Technical Service Information

THM 440-T4 HARSH REVERSE ENGAGEMENT

Figure 1

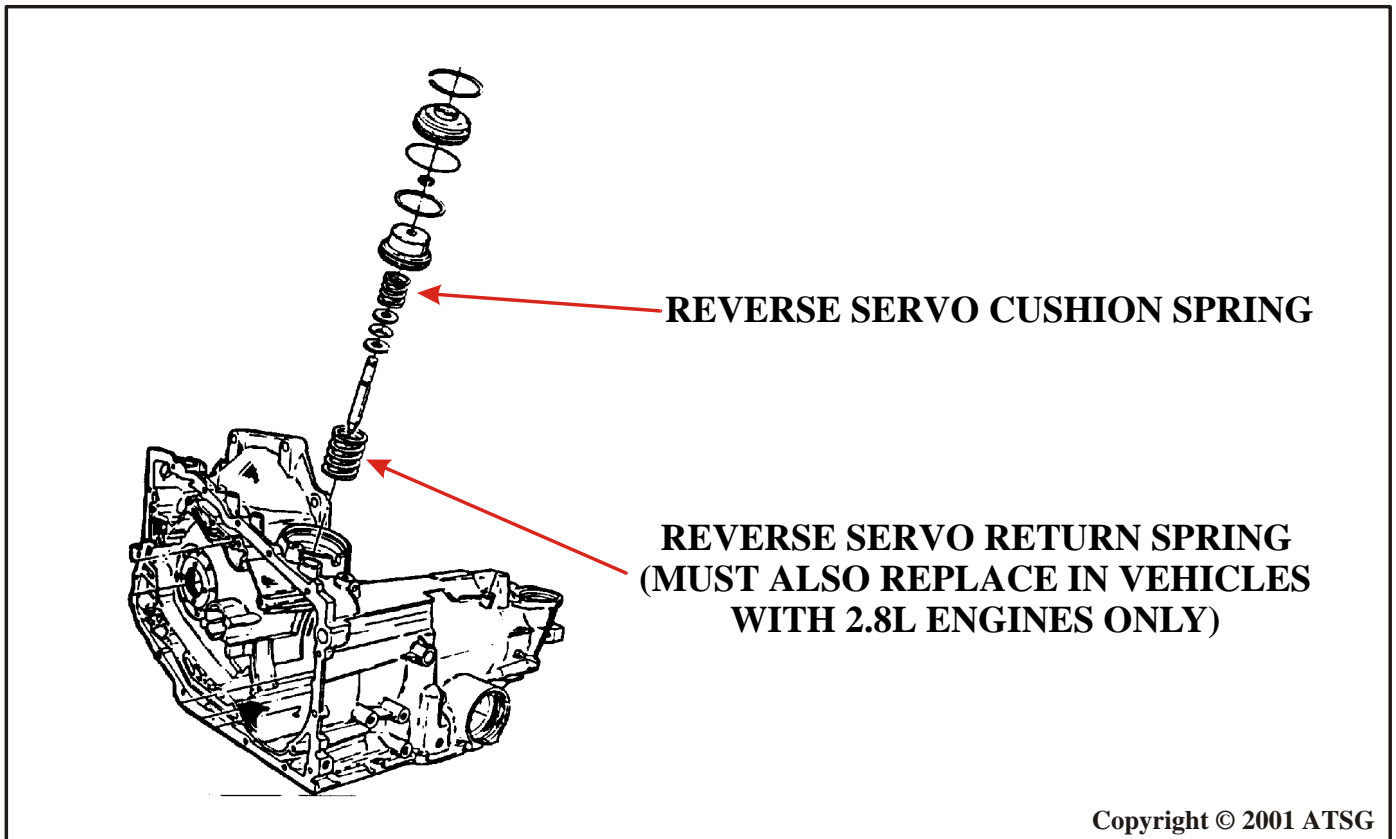
COMPLAINT: Harsh Garage Shift From Park/Neutral To Reverse.

CAUSE: The cause may be:

1. Low vacuum supply to the vacuum modulator.
2. Stuck modulator valve in case.
3. No. 9 checkball missing or off location.

CORRECTION: AFTER ALL OF THE ABOVE ARE ELIMINATED:
There is now available a new Reverse Servo Cushion Spring, and a new Reverse Servo Return Spring. Replacing these springs should correct the harsh reverse condition. The reverse servo return spring should only be replaced on the 2.8L engines.

Spring, Reverse Servo Cushion (All).....	8668121
Spring, Reverse Servo Return (2.8L Only).....	8668127
